THE ILLUSION OF ENVIRONMENTAL PROTECTION

PERMITTING LONGWALL COAL MINES IN PENNSYLVANIA

Schmid & Company, Inc., Consulting Ecologists

This report provides an in-depth, independent review of the Foundation Mine permit application and its review by the CDMO. This analysis provides a unique insight into the current regulatory review process involving longwall coal mines in Pennsylvania. It examines how well the current review process implements the laws and regulations adopted to protect environmental resources from coal extraction activities. This report uses the Foundation Mine application as a case study to determine how successfully the Pennsylvania Department of Environmental Protection requires an applicant to inventory resources at risk from a proposed longwall mine operation, predict potential impacts, and identify measures to minimize and address likely impacts in accordance with existing laws and regulatory requirements. The report also examines the adequacy and effectiveness of the State's mine permit application forms, technical guidance, and overall process in eliciting the information necessary to evaluate potential impacts and to demonstrate compliance with applicabl

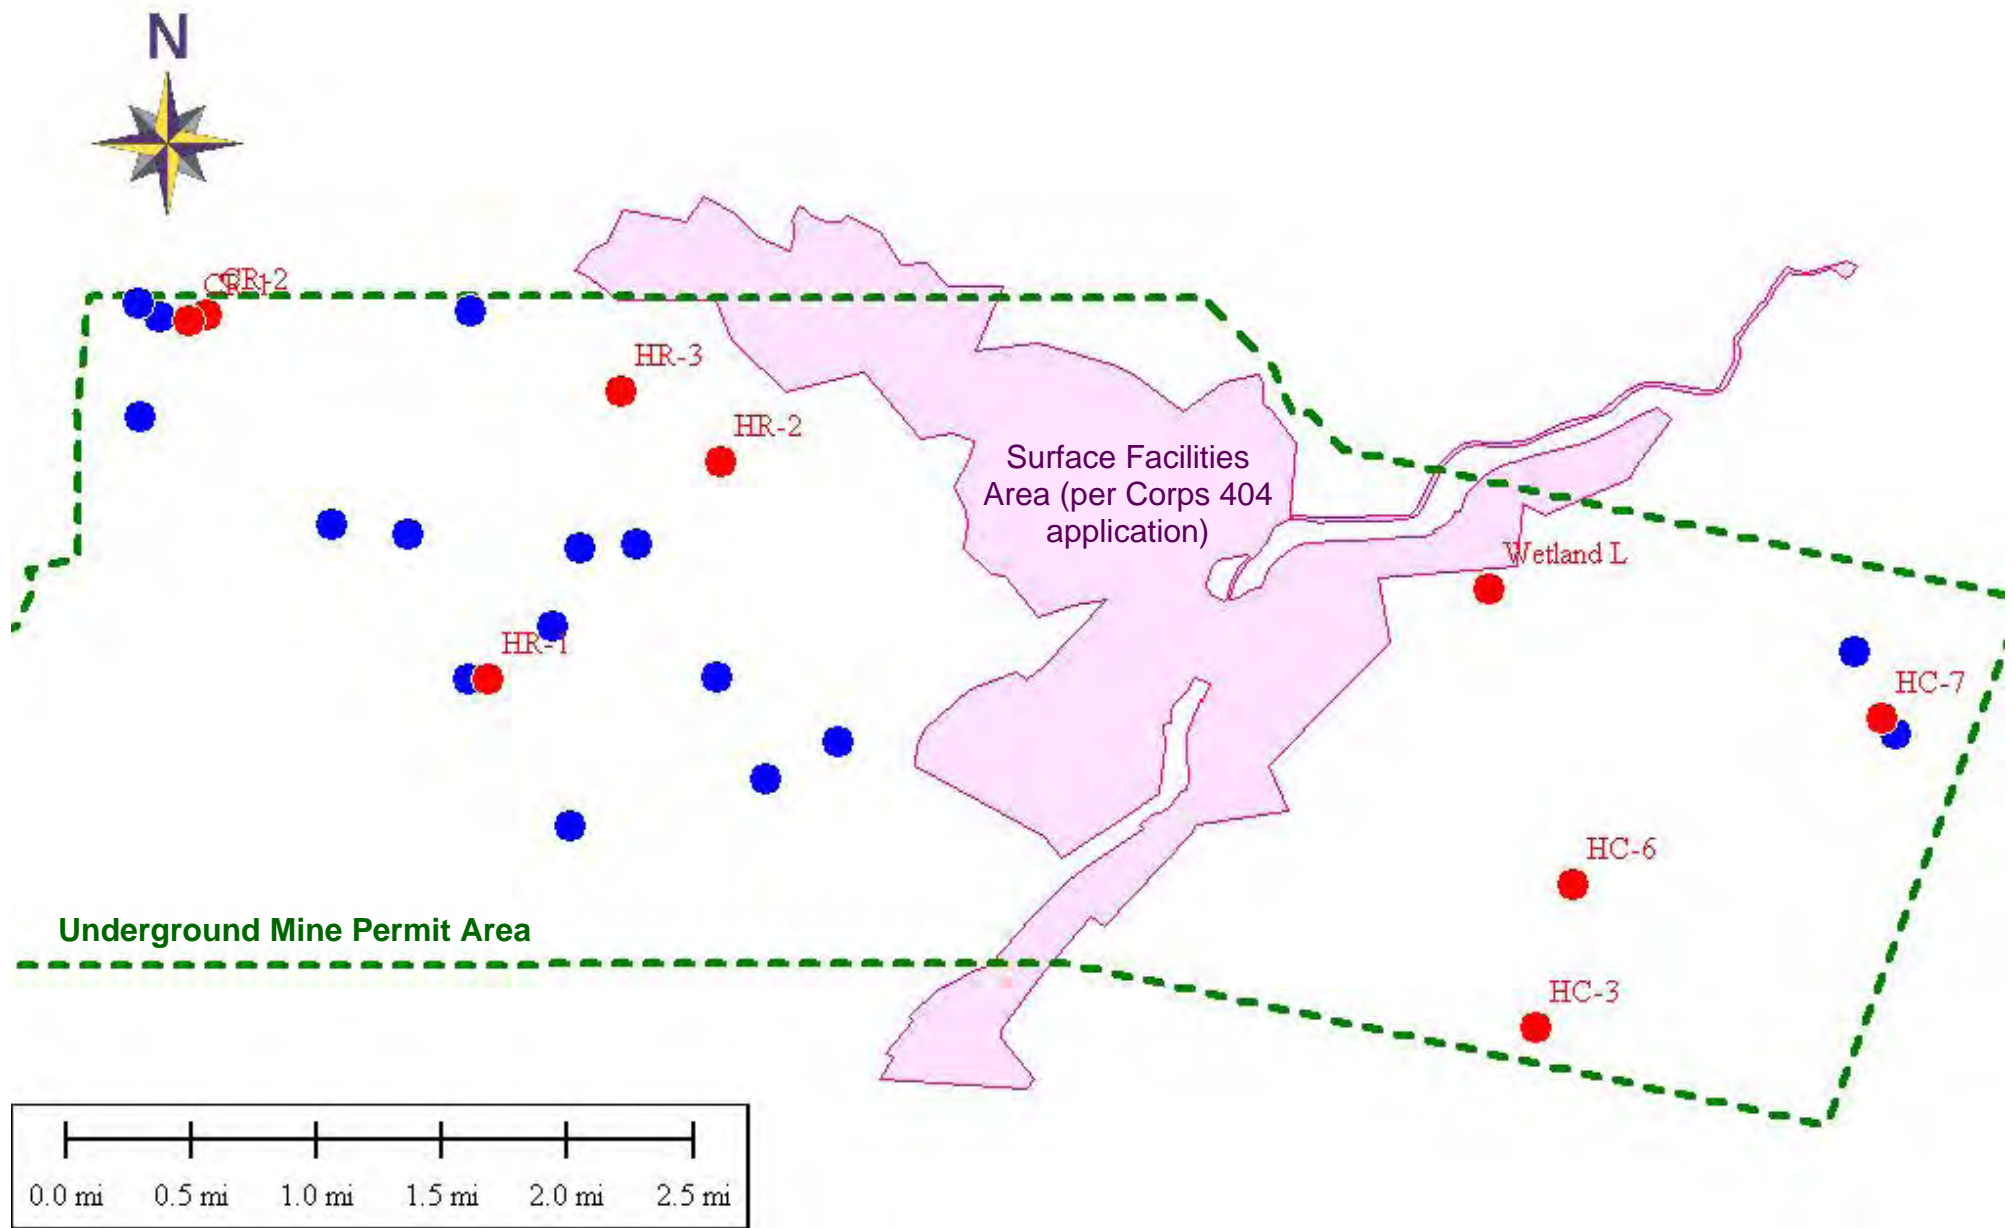
observed as well (**Figure 7**). Clearly, the CDMO was remiss in not seeking to confirm the accuracy of the wetland delineations outside of the surface activity areas as part of its review of the Foundation Mine permit application.

of Foundation Mine outside of the surface activities area. Numerous additional wetlands were observed (see **Figure 7**), wetlands that were not delineated in this permit application or reviewed/confirmed by Corps JD. One wetland of significant size (approximately 5 acres) was observed along the south side of Bristoria Road, within State Game Lands #179 (see **Figures 6a** and **6b**).

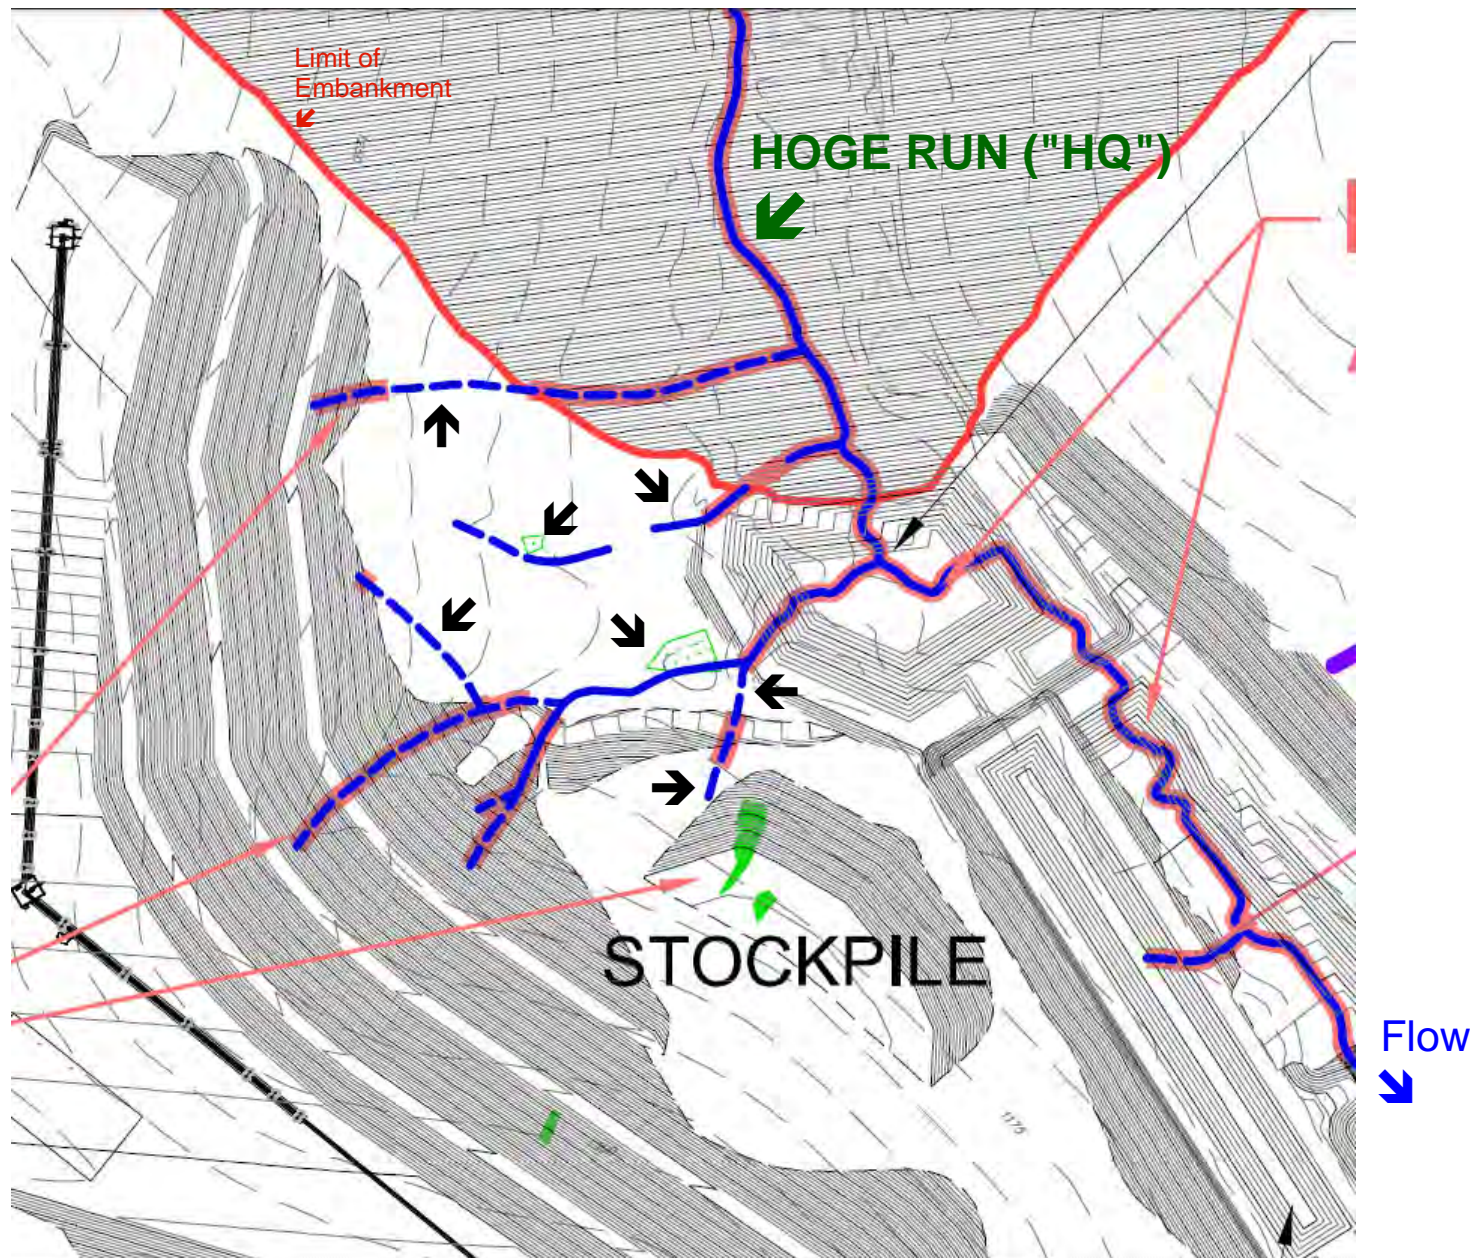
In some cases, even direct impacts were overlooked. For example, in the vicinity of the proposed Batch Weigh Loadout area, the rock outfall from a proposed sediment trap was shown on a drawing as extending into a corner of Wetland H (**Figure 9**). The footprint of that outfall, and any disturbance area around it necessary to install it, were not identified among the proposed wetland impacts anywhere in the State (or Corps) application.

Furthermore, in light of the significant amount of regrading proposed in the near vicinity of Wetland H, plus the proposed loss of the surrounding forest habitat, and the hydrologic disruptions proposed nearby (including the collection of sheet runoff and its redirection through manmade diversion ditches around proposed soil stockpiles), the hydrologic balance of all of Wetland H (as well as Wetland I just upstream from it) would be significantly impacted. Additionally, the Corps JD confirmed that Wetland H was 0.38 acre, or almost twice as large as was shown in the State coal mine application, so the actual direct and indirect impacts to it might be even larger than the 0.20 acre acknowledged in the 2010 application.
